## SERVICE BULLETIN

**Bulletin No:** JC-13-18

**Product Type:** STEINER

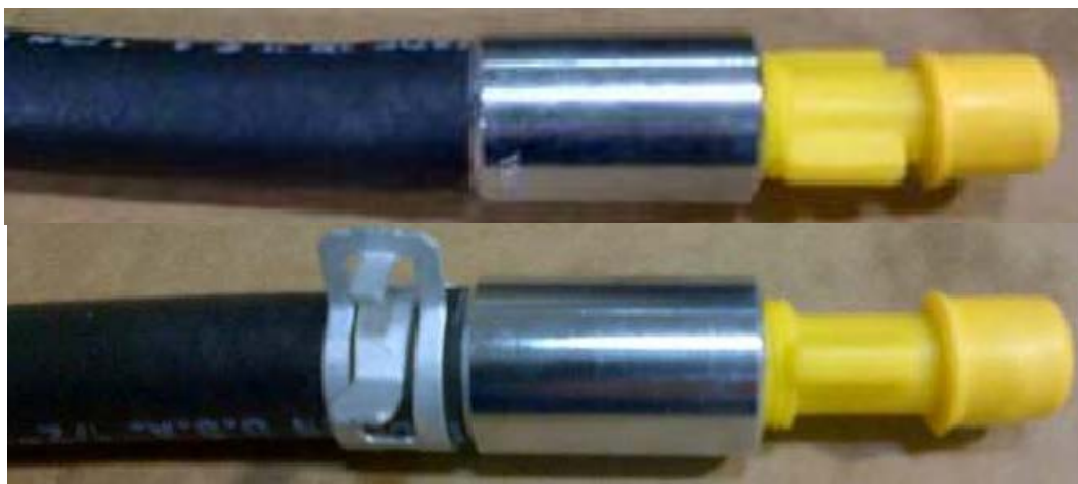
**Customer Issue:** The valve on the end of the Kubota engine oil drain hose can be removed too easily and cause a possible oil loss.

**Cause:** There is no hose clamp to hold the valve tight in the hose.

**Action required:** Install a hose clamp on the engine oil drain hose.

7572010 Kubota diesel tractors order a hose clamp: 88042-05

7572011 Kubota gas tractors order a hose clamp: 88042-03
